**Re: Tri-County Regional Vocational Technical High School
147 Pond Street
MassDEP File No. 159-1291
Notice of Intent Peer Review Update**

BETA Group, Inc. (BETA) has reviewed revised documents and plans for the ***Tri-County High School development***, located at ***147 Pond Street*** in Franklin, Massachusetts. This letter is provided to update BETA's findings, comments and recommendations.

PEER REVIEW UPDATE

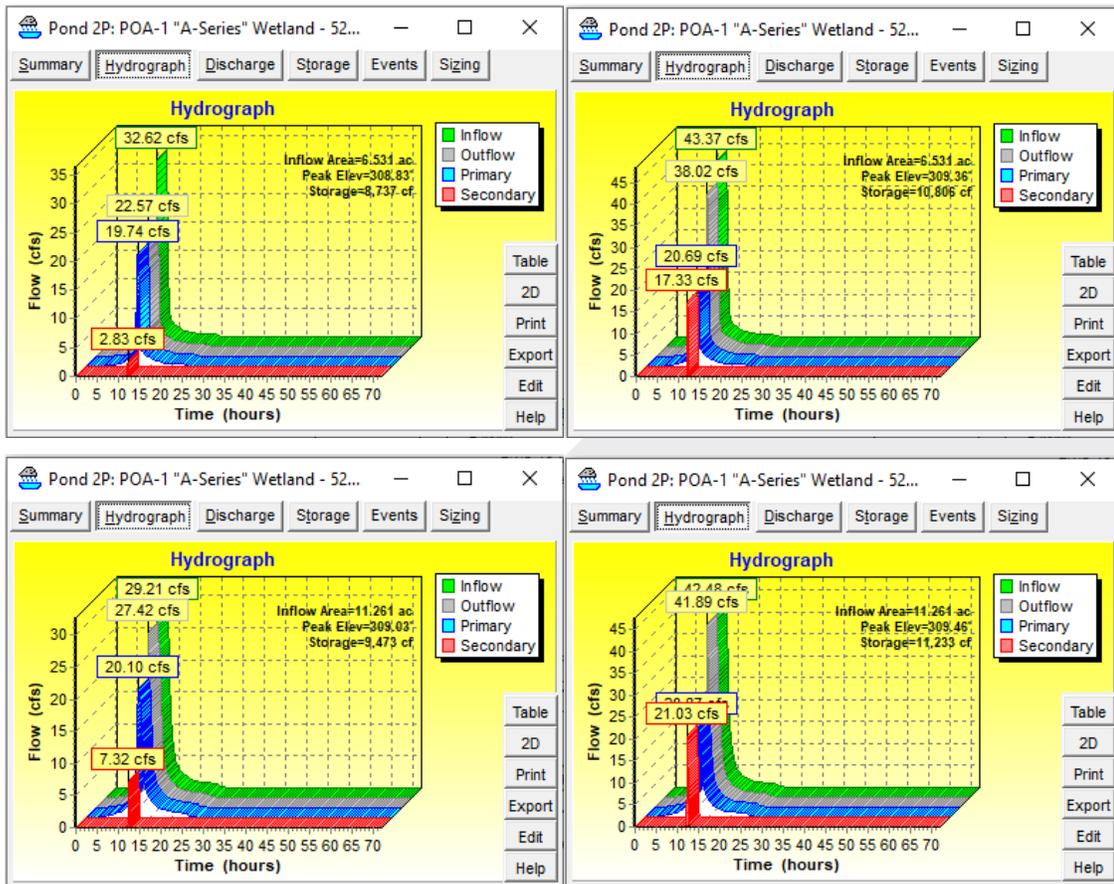
SW31. Provide table comparing pre- and post-development runoff volumes for each watershed area to evaluate flooding impacts to wetland resource areas and downgradient properties.

SCI: Refer to Response to Comment SW16 for table comparing pre- and post-development runoff volumes for each watershed area. To evaluate the impacts for increasing volumes to the "A-series" and "B-series" wetlands, the wetlands were included as Ponds in both the existing and proposed HydroCAD models. Given the surface contours and volume available at each wetland, the model shows some overtopping at the "A-series" wetland in the existing condition at the 25- and 100-year storm events. Reviewing existing topography, theoretical runoff that overflows from the "A-series" wetland appears to run down the vegetated slope alongside Tri-County Drive to the inlet upgradient from the existing access drive. Any flows that do not get captured by the inlet appears to be directed on to Tri-County Drive or continue down and alongside Tri-County Drive. In the proposed condition, it appears that runoff will overtop the "A-series" wetland also during the 25- and 100-year storm events, but to a greater degree than existing. "A-series" Wetland Overflow in Existing (top) and Proposed (bottom) at 25-year (left) and 100-year (right) Storm Events

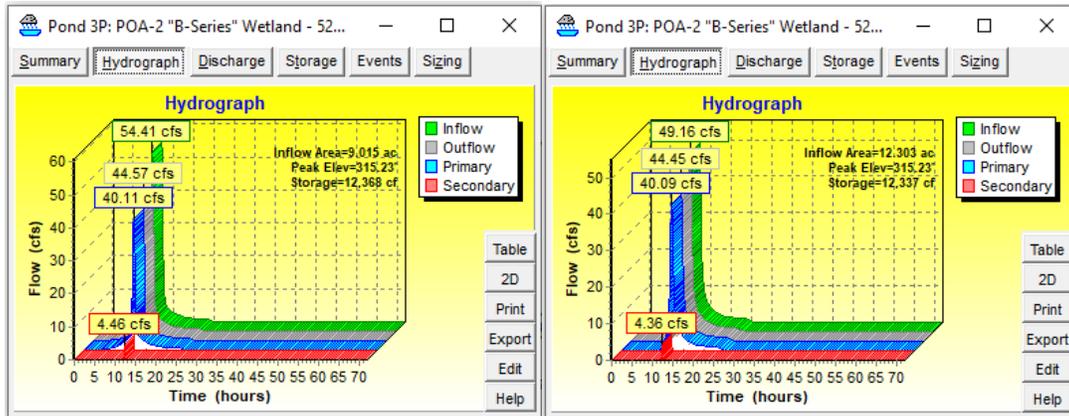
For the "B-series" wetland, the model appears to show that the runoff overtops the wetland in both the existing and proposed conditions at the 100-year storm event. The runoff that overflows from the wetland is slightly less in the proposed condition. "B-series" Wetland Overflow in Existing (left) and Proposed (right) at the 100-year Storm Event

For the additional runoff directed to the 12" RCP in Tri-County Drive, the pipe capacity was evaluated and no conflicts were found per the hydraulic rational calculations provided within the stormwater report appendices.
